Initial Submission Review

ALTON STREET DUPLEXES WITH WAIVERS

SITE PLAN

LOT 43 TO 48, BLOCK 63, LOCATED IN THE SOUTHWEST 1/4 OF SECTION 34, TOWNSHIP 3 SOUTH, RANGE 67 WEST OF THE 6TH P.M. CITY OF AURORA, COUNTY OF ADAMS, STATE OF COLORADO SITE ADDRESS: 1775-1795 ALTON ST., AURORA, CO

LANDSCAPE PLAN

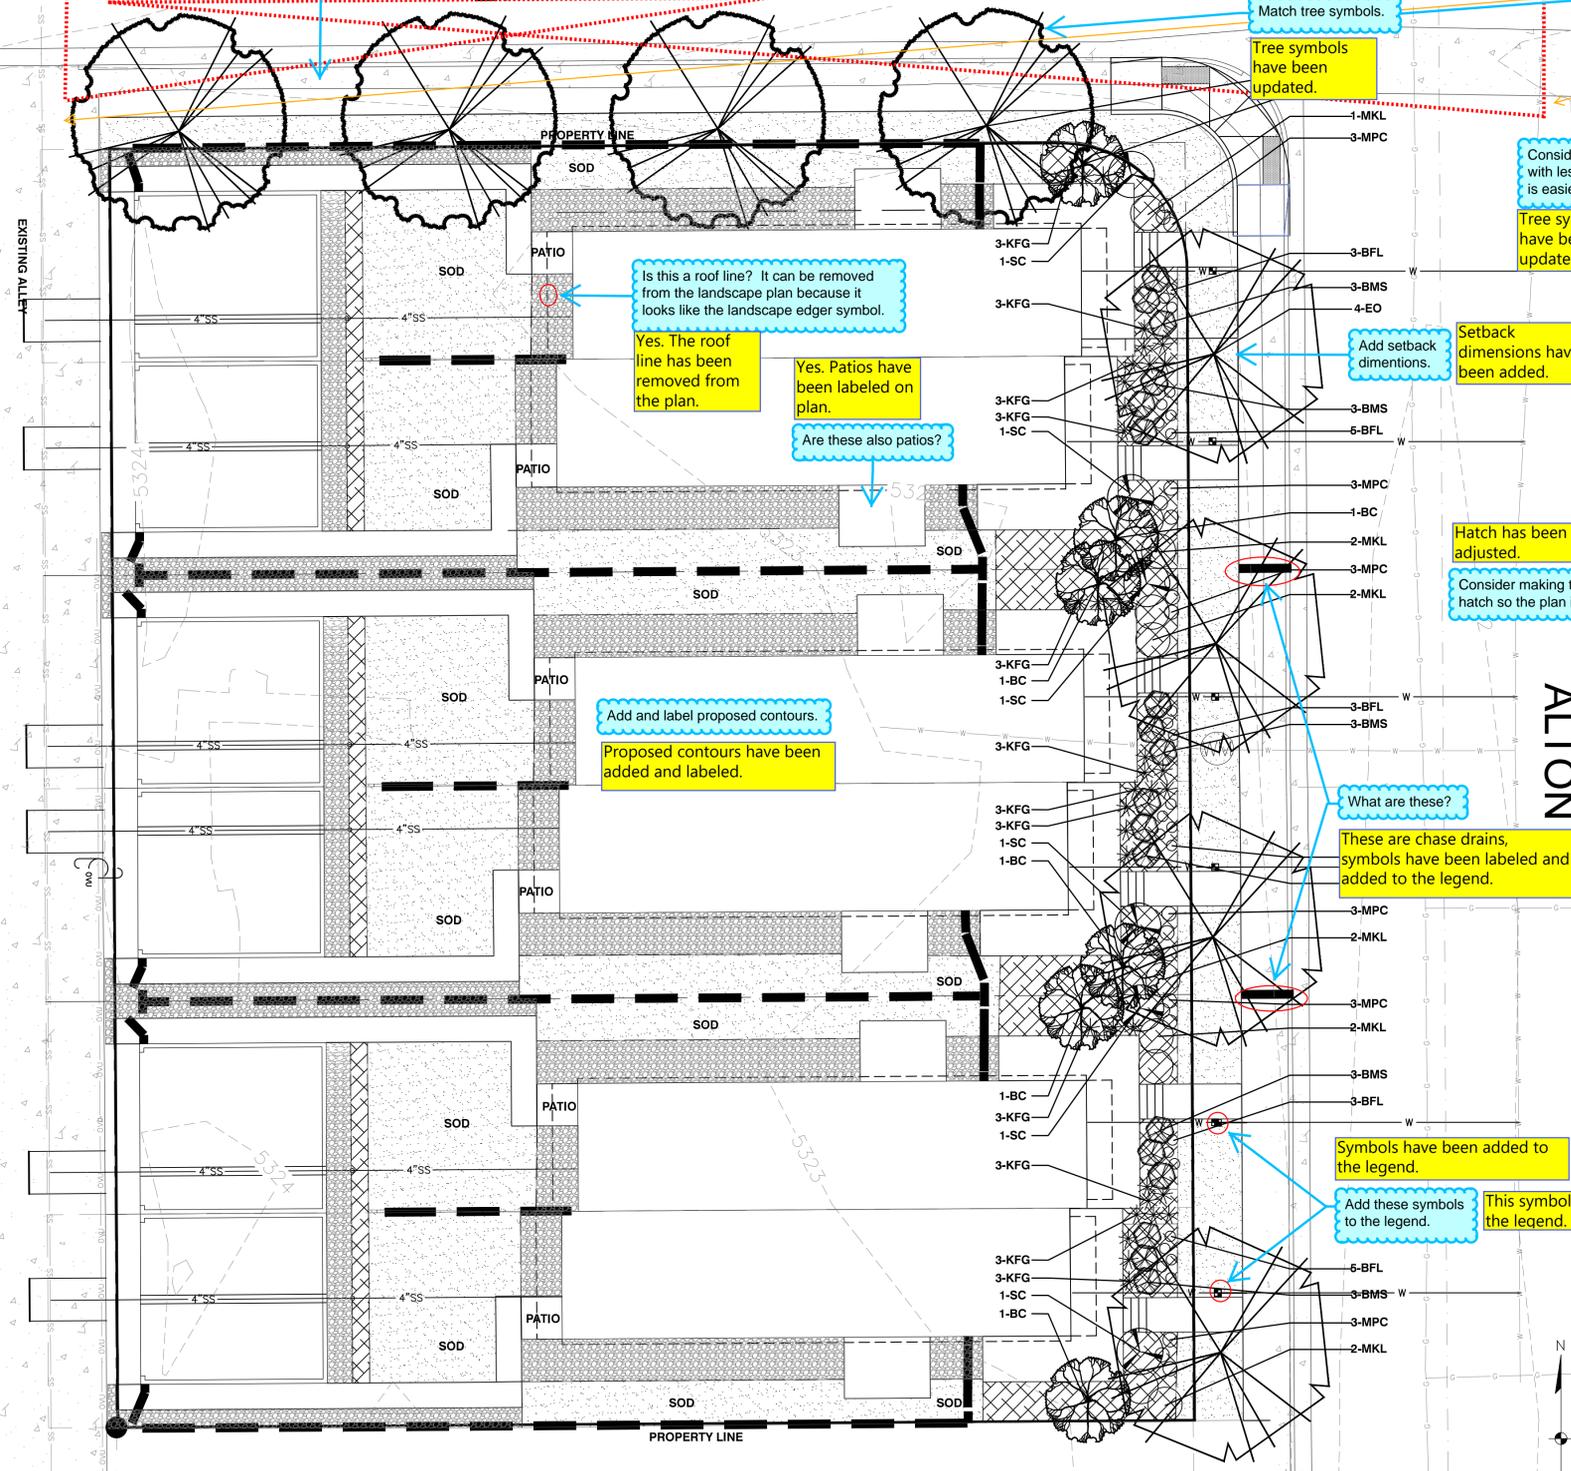
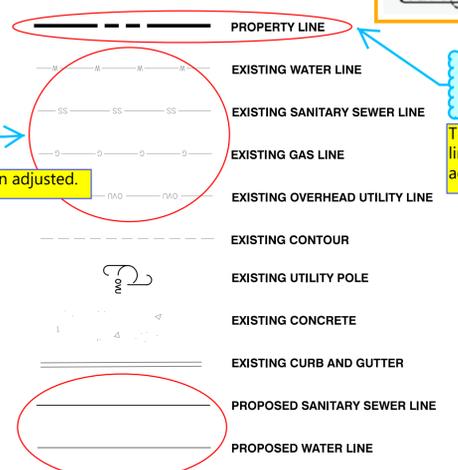
Add setback dimensions.

Show sight triangles per COA STD TE-13.1 - Applies to all driveways. Any proposed plants in the triangle must comply with City required vertical requirements. Up size / revise plants as necessary. Add note: 'All proposed landscaping within the site triangle shall be in compliance with COA Roadway Specifications, Section 4.04.2.10'

These linetypes are upside down.

The property line must be clear on the landscape plan.

Linetypes must match the plan.

Add proposed contours.

Add "Not For Construction".

Scale bar is not correct. Scale has been updated.

Is this a roof line? It can be removed from the landscape plan because it looks like the landscape edger symbol.

Are these also patios?

Add and label proposed contours.

Match tree symbols.

Consider using a tree symbol with less line work so the plan is easier to read.

Add setback dimensions.

Consider making this a grayed hatch so the plan is more readable.

What are these?

Add these symbols to the legend.

Setback dimensions have been added.

Sight triangles have been added and labeled.

Linetypes have been adjusted.

The property line has been adjusted.

Linetypes have been adjusted.

Proposed contours have been added to the legend.

"Not for Construction" has been added to the plan set.

Yes. The roof line has been removed from the plan.

Yes. Patios have been labeled on plan.

Proposed contours have been added and labeled.

Tree symbols have been updated.

Tree symbols have been updated.

Setback dimensions have been added.

Hatch has been adjusted.

These are chase drains, symbols have been labeled and added to the legend.

Symbols have been added to the legend.

This symbol has been added to the legend.

REQUESTED WAIVERS

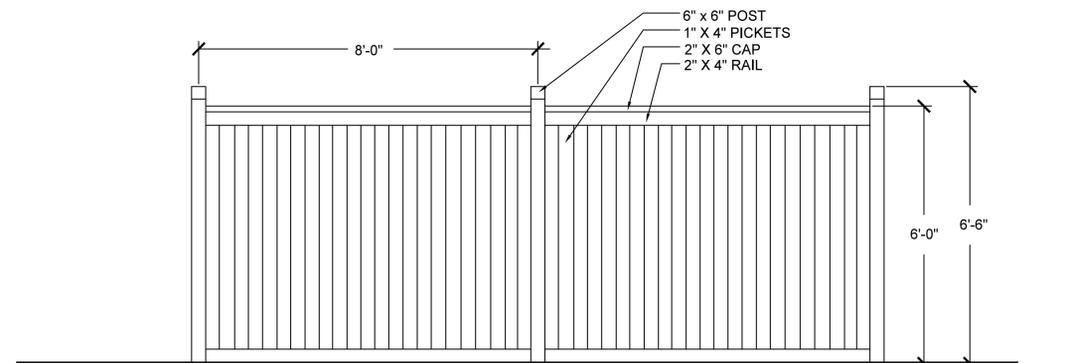
Waivers for setbacks only should be on Cover Sheet.

Waivers have been removed.

1775ALTON-8-6-17-backup.dwg
LANDSCAPE NOTES AND DETAILS

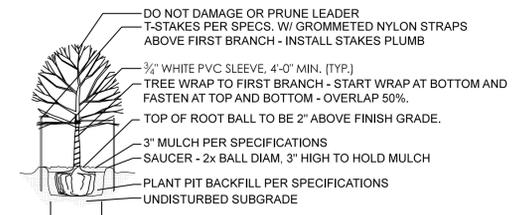
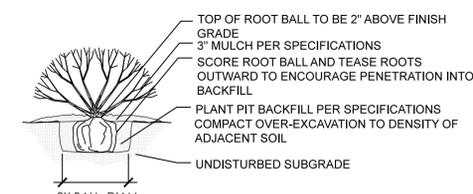
Remove these columns Columns have been removed.

This requirement is not shown on the landscape plan.

Please add the following note: STREET TREES WILL BE PLANTED IF INSPECTION CONFIRMS THAT TREES HAVE BEEN PLANTED PER THE CITY SITE PLAN DETAIL; APPLICANT/DEVELOPER REQUIRED TO CONTACT THE CITY FOR AN INSPECTION TWO DAYS IN ADVANCE OF PLANTING. THE CITY OF AURORA FORESTRY DIVISION SHALL TAKE OWNERSHIP OF ALL STREET TREES AFTER THEY ARE PLANTED AND WILL BE RESPONSIBLE FOR THE MAINTENANCE OF THOSE TREES IN PERPETUITY.

Add note saying that freestanding lights are not proposed with this Site Plan.

Add "Not For Construction".

The side yard is not exposed to public view. a 6' privacy fence will be installed.

Text has been updated.

Text has been updated.

Note has been added to the plan set.

"Not for Construction" has been added to the sheet.
